CITY PROJECT # 07-24

PALM SPRINGS ANIMAL CARE FACILITY

ADDENDUM NO. 2

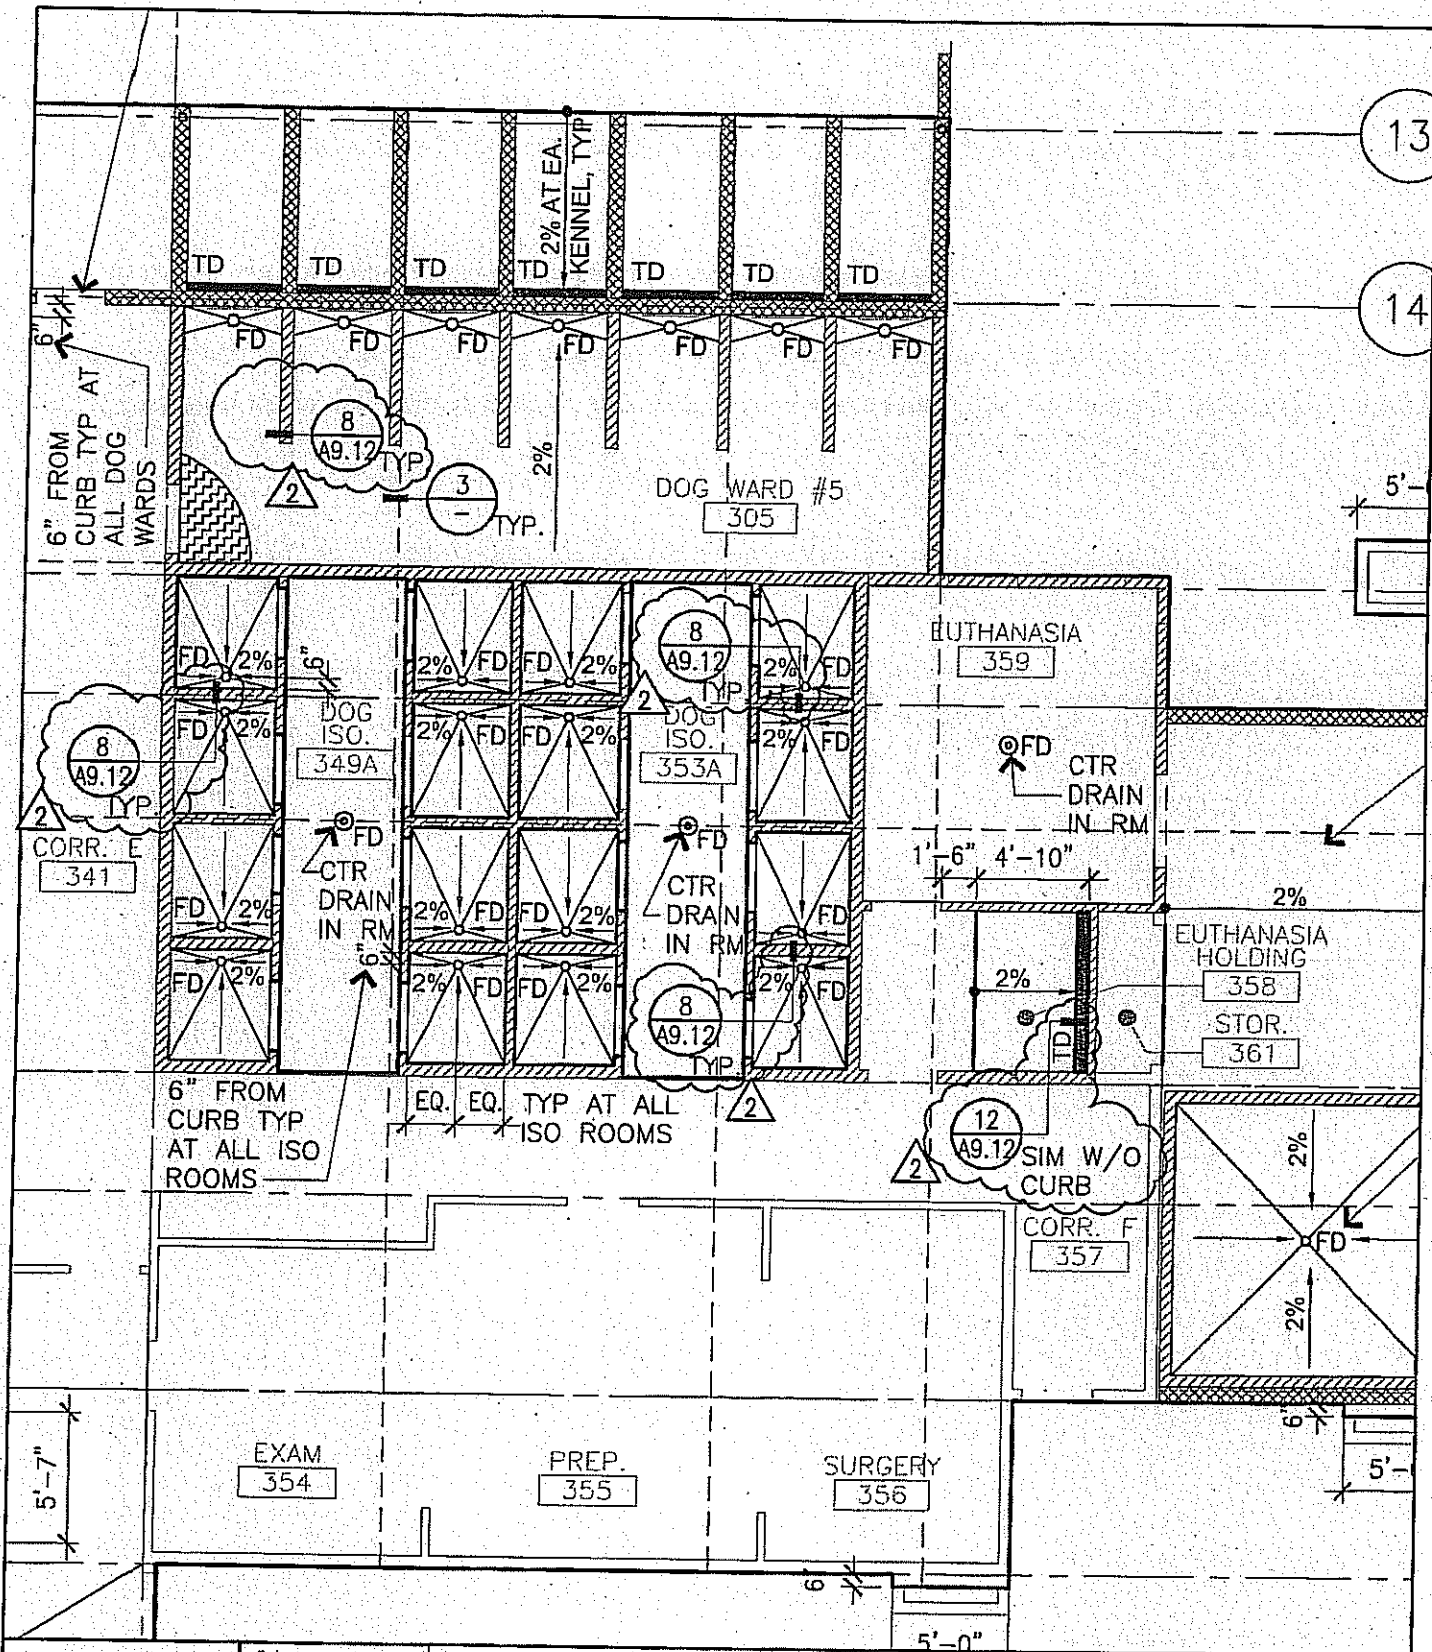
4. Reference: Architectural Drawing Sheet A2.03, Interior Slab Plan: South of Column Line 14 between Grid Line E thru M there are masonry dividing walls shown on this drawing and at the North Side of Column Line 11 between Grid Line E thru M there are masonry dividing shown on this drawing. On Structural Drawings S2A & S2B, Foundation Plan A & B: There are no masonry walls shown in these areas. Please provide details on what type of dividing walls are required in these two areas. Please clarify.

A2-A2 (Reference Drawings No. A2.03):
Added Reference Detail Tags to Sheet A2.03

See response to #3 above. locations noted are raised concrete curbs with epoxy resin coating finish (not CMU walls) as identified in the Slab Plan Legend. The CMU wall occurs on the exterior side of the Dog Wards in the Adoption Courtyard.

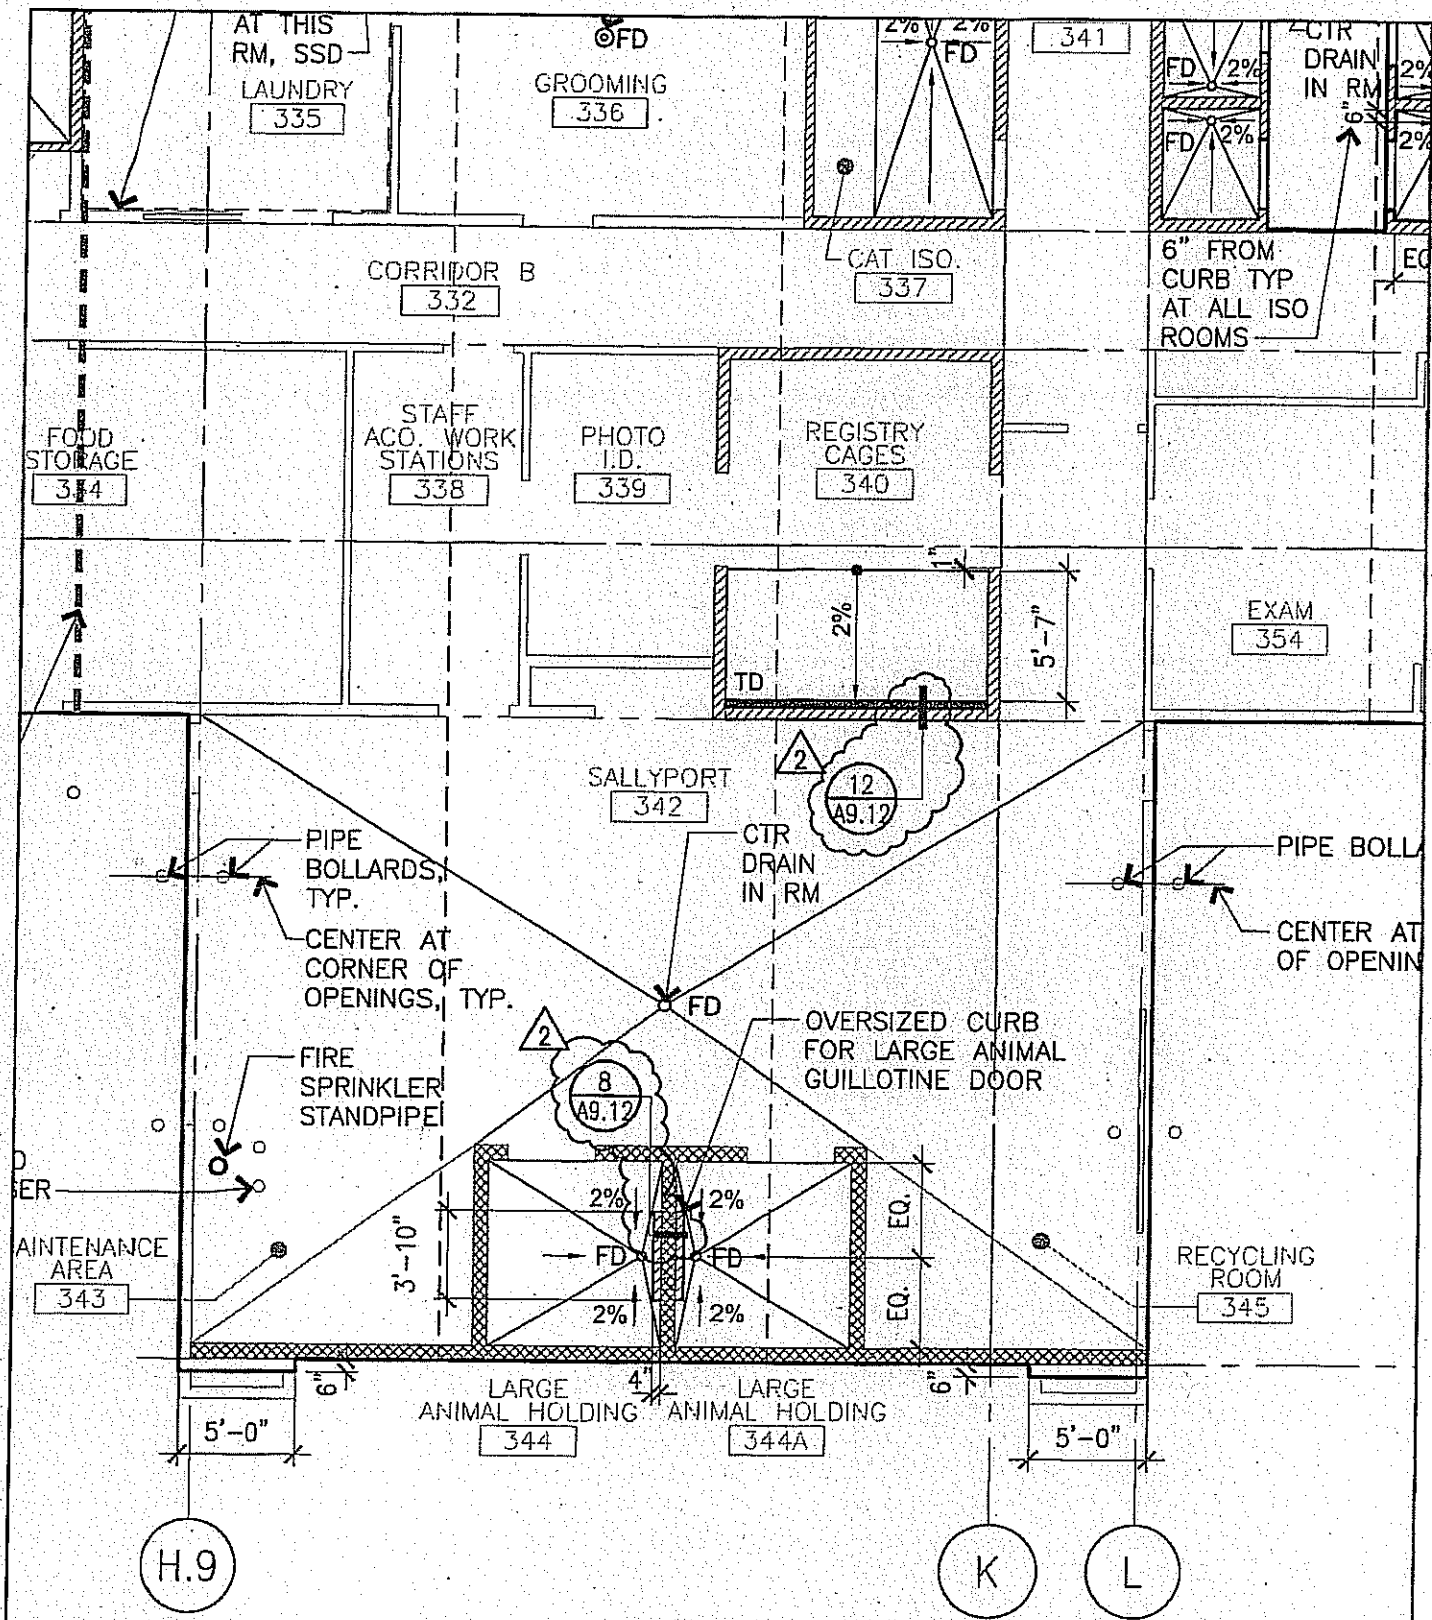
A2-A3 (Reference Drawings No. A2.03):
Added Reference Detail Tags to Sheet A2.03

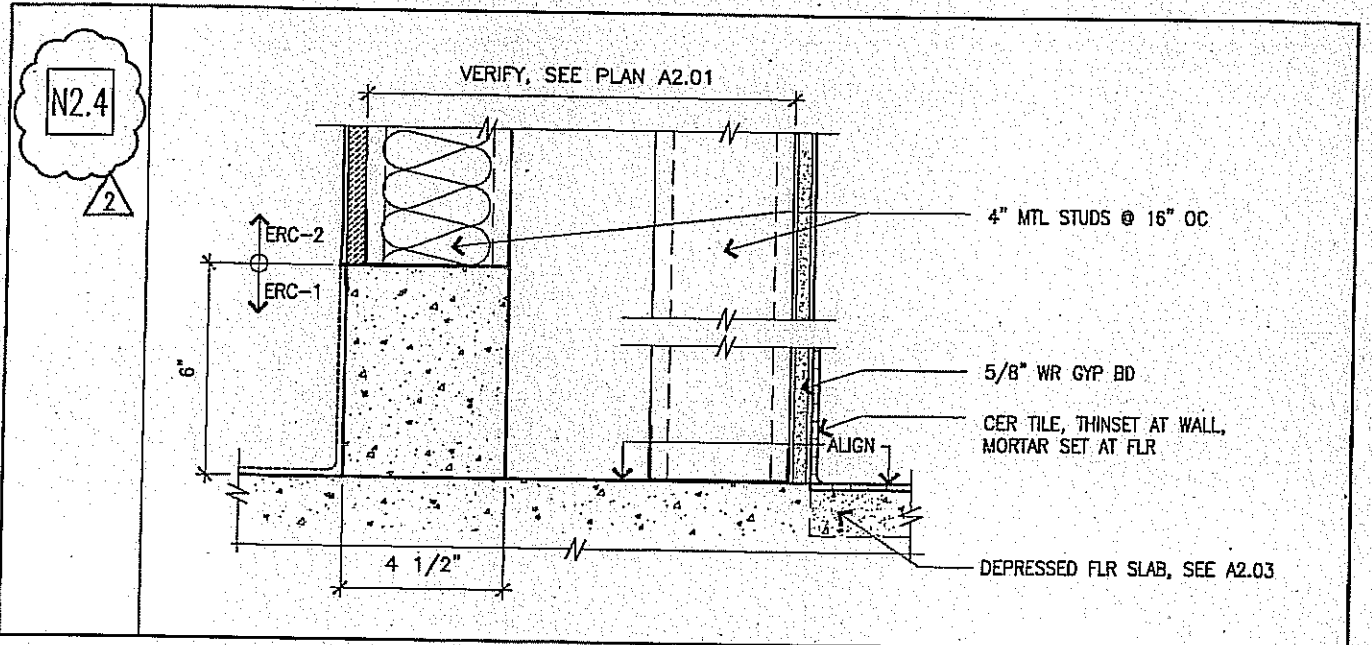
Refer to East wall of Woman 317. I don't find wall NC2.3. Should this be N2.3? Please clarify.

A2-A6 (Reference Drawing A10.01): Added New Wall Type N2.4.

East Wall Woman 317 is New Wall Type N2.4.

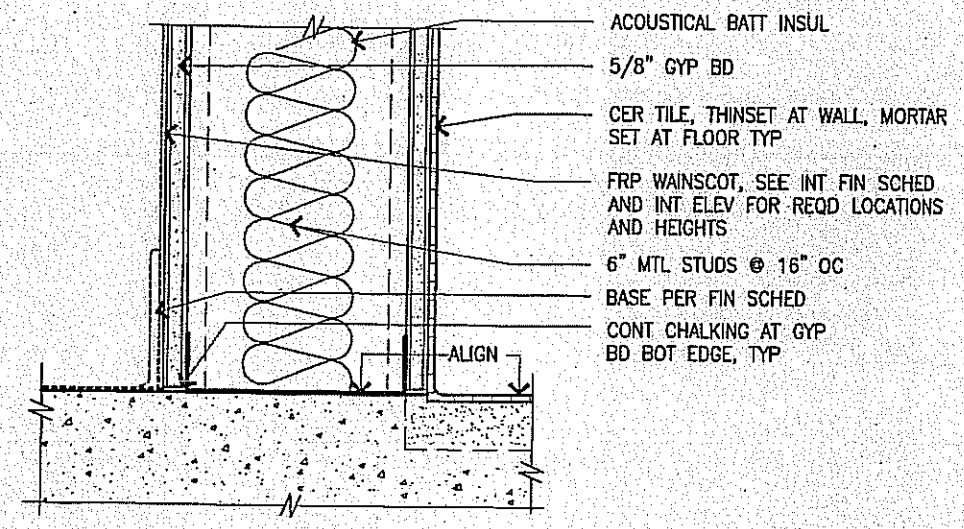
Refer to West wall Retail 112. Wall Type N2 does not seem correct. Please clarify wall type.

A2-A7 (Reference Drawing A10.02): Added New Wall Type M2.

West Wall at Retail 112 now reads Wall Type M2.

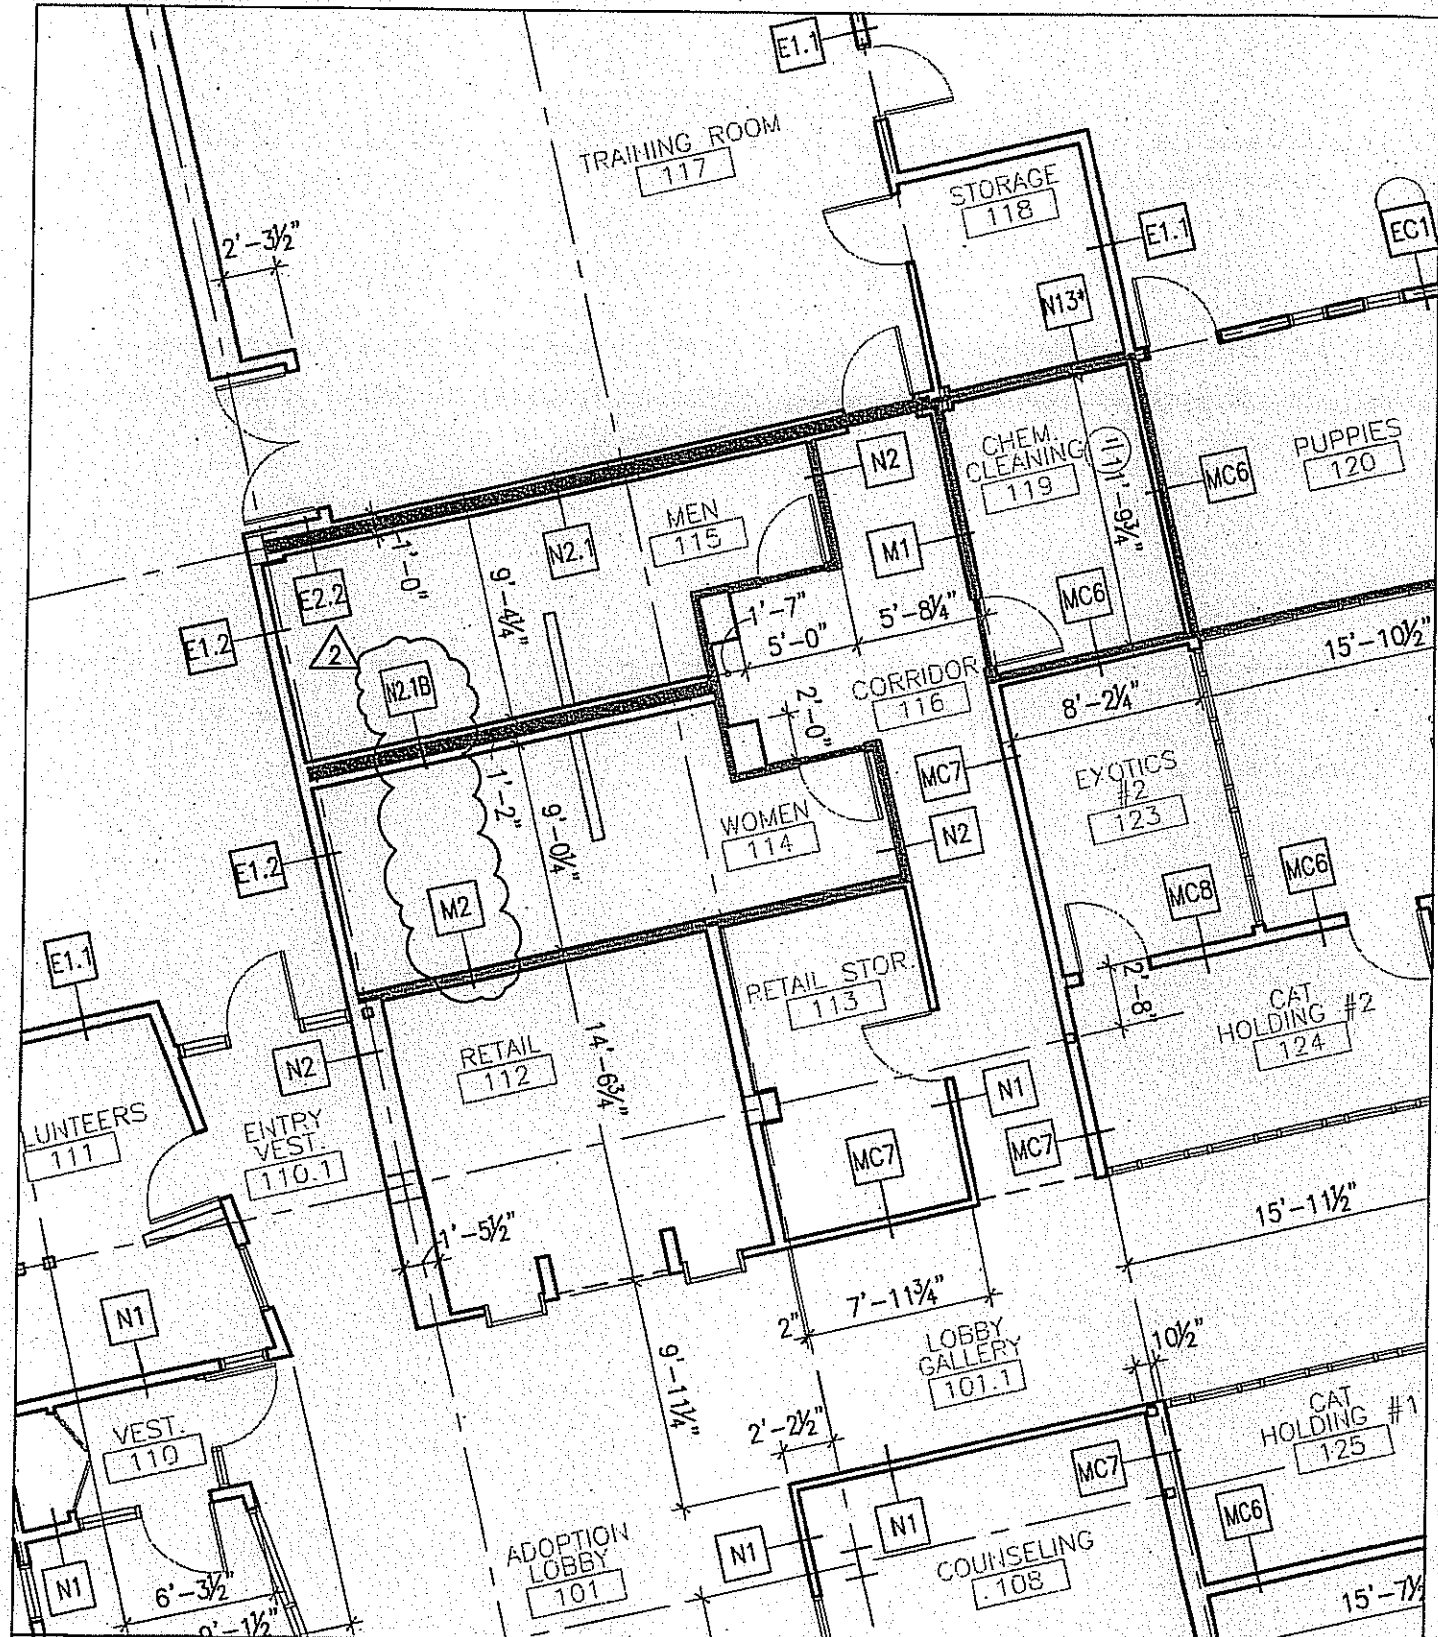
A2-A8 (Reference Drawing A2.01): Revised Wall Types Noted.

Wall at Toilets 114 and 115 now reads Wall Type N2.1B.

South Wall at Dispatch Wall Type N18 is void, Wall Type is N1.

South Wall at Intake Exam 203 is Wall Type NC3.

North Walls at Rooms 333, 334, 338, and 339 are Wall Type N1.

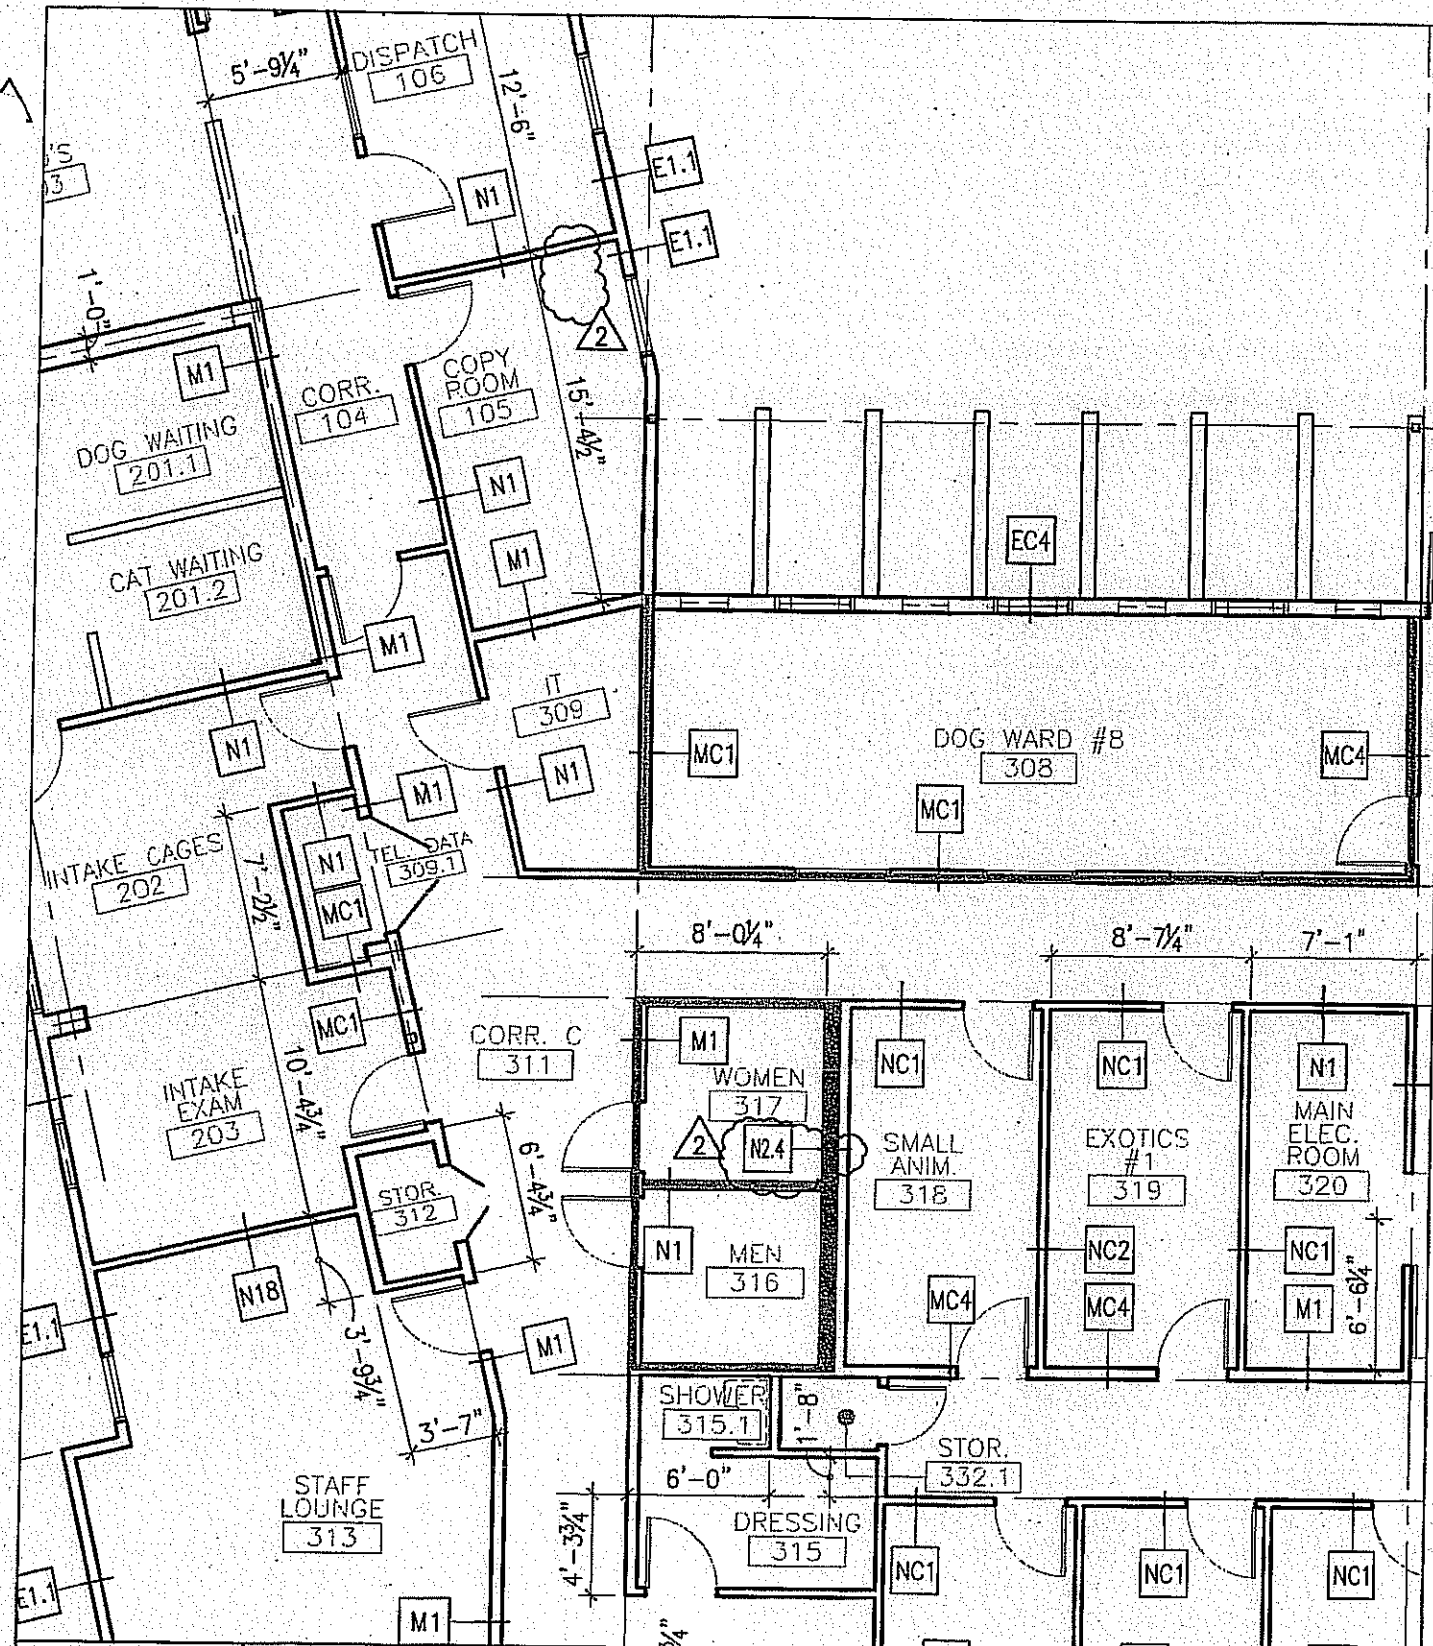
A2-A9 (Reference Drawing A2.01): Revised Wall Types Noted.
